Access Compliance Report

Public Rights-of-Way

Intersection ID: 12629	Main Street: E_6TH_ST	Cross Street: N_DAVIDSON_ST	Location: E
ADA ID: 5CBBF489D2CD	Ramp Type: PerpDiag	Initial Pass/Fail: Fail	Overall Compliance: No
		Severity Score: 55

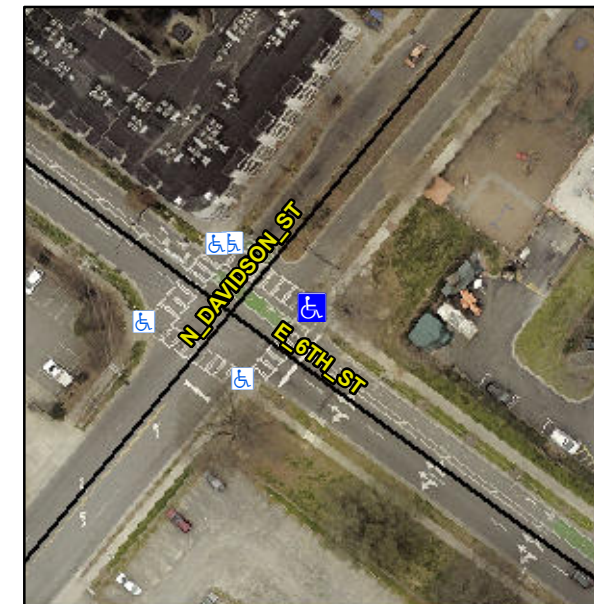
Not Found, R304.5.1, R304.2.2, R304.5.3

Compliance	Description	Data	Compliance	Description	Data
N/A	Ramp Length (in)	92.0	No	Ramp Slope (%)	9.0
No	Ramp Width (in)	32.0	No	Ramp XSlope (%)	7.7
N/A	Flare Type LT	N/A	N/A	Flare Type RT	N/A
N/A	Flare Slope LT (%)	N/A	N/A	Flare Slope RT (%)	N/A
N/A	Flare Traversable LT?	N/A	N/A	Flare Traversable RT?	N/A
N/A	Landing Length (in)	N/A	N/A	DWS Provided?	N/A
N/A	Landing Width (in)	N/A	N/A	DWS Contrast?	N/A
N/A	Landing Slope (%)	N/A	N/A	DWS Length (in)	N/A
N/A	Landing X Slope (%)	N/A	N/A	DWS Full Width?	N/A
N/A	Landing Curb? (Y/N)	N/A	N/A	DWS Offset (in)	N/A
N/A	Shared Landing?	N/A			
N/A	Gutter Ponding?	N/A	N/A	Gutter Slope (%)	N/A
N/A	Gutter Lip Ht (in)	0.5	N/A	Gutter X Slope (%)	N/A
N/A	Painted X Walk1?	Yes	N/A	Painted X Walk2?	Yes
	X Walk 1 Direction	To NW		X Walk 2 Direction	To SW
N/A	X Walk 1 Width (in)	105.0	N/A	X Walk 2 Width (in)	106.0
	X Walk 1 Slope (%)	8.4		X Walk 2 Slope (%)	0.5
	X Walk 1 X Slope (%)	2.1		X Walk 2 X Slope (%)	6.7

Remove & Replace Curb Ramp With Two New Directional Ramps or Equivalent.
